DVOR Rationalisation

Renaming & Removing Outstanding Enroute IFP dependencies on ground-based NAVAIDs

Phase 1 Holds and STARs

Reference 9: Stakeholder Evidence for Stage 4
As summarised in Appendix 15.7 of the Stage 4 ACP Documentation

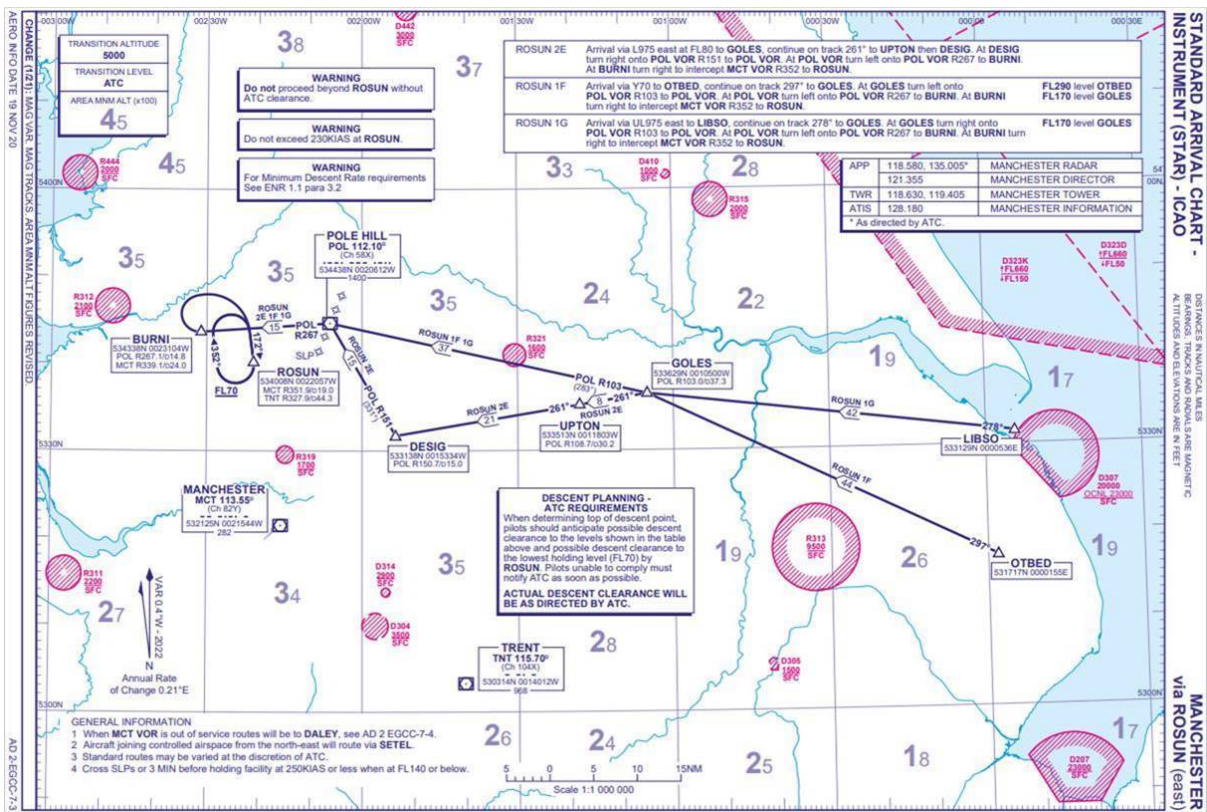
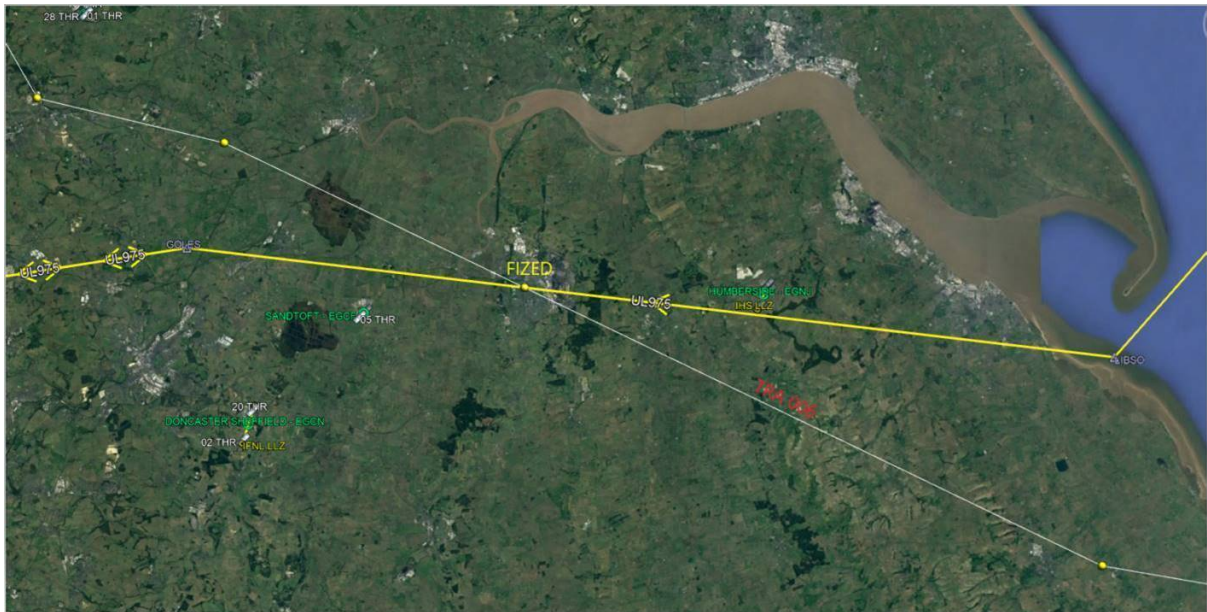
Apologies I did mean to raise this with you last week and it slipped my mind. As part of a couple of the final DVOR ACP's we have running just now we are RNAV'ing STAR's into some of the MTMA airfields. We have generally tried to replicate the existing procedures so there is minimal change in terms of what the controllers see and pilots fly. Some existing STARs have planning levels mentioned on the STAR plate but which exist before the start of the STAR. In these cases we have extended the STAR's back to the point the level restriction is based on in order to capture the standing agreement level and not lose it, as we can't have planning levels now which are not coded into the procedure. There is a standing agreement level which is reflected on many of the STAR's for East Midlands, Birmingham, Manchester and Liverpool at LIBSO, which is on UL975, so we have extended the STAR back to LIBSO in line with other STAR's. UL975 goes over the top of TRA006, and the plan is that the STAR will do likewise. We have created a new point 'FIZED' on UL975 which is basically on the boundary of the TRA. This will enable controllers to descend the aircraft to FL250 by FIZED (i.e. the lowest they can to remain above the TRA) which gives them the best opportunity to lose the height in time to get in to the MTMA. A/C are often vectored off the STAR as the TRA leaves them too high, but as DVOR is a 'replication' and not a re-design project, this is the best option we have come up with. Flight planning will restrict planning onto the STAR such that it can't be joined from below (from inside the TRA), as this was another concern that was raised by the CAA (I'm not clear how that could have happened but I'm best to let you know it won't be able to happen).

To summarise, traffic that previously would have picked up a STAR at GOLES after flying along UL975 from LIBSO, will now start the STAR at LIBSO. They won't be able to file below FL250 to remain above the TRA, and we have established a new point on the boundary of the TRA on UL975 to enable controllers to descend aircraft and define when they have past the TRA and issue further descent. We could have inserted a planning level at FIZED but this would have restricted the A/C even when the TRA isn't active and we are hoping that this solution is satisfactory to everyone, including the CAA.

The CAA asked specifically for evidence of engagement with the MOD on this, hence me sending it on. I'm happy to set up a call to cover it if required. Is this something you could assist with, and provide some feedback?

Actually just checking again, the Manchester STAR already goes back to FIZED so there isn't really anything new there other than the planning levels, but other airfields STAR's would be extended back to LIBSO which will mimic this and all would utilise the new point at FIZED.

Thanks for the engagement. MOD has no objection to the proposed changes.
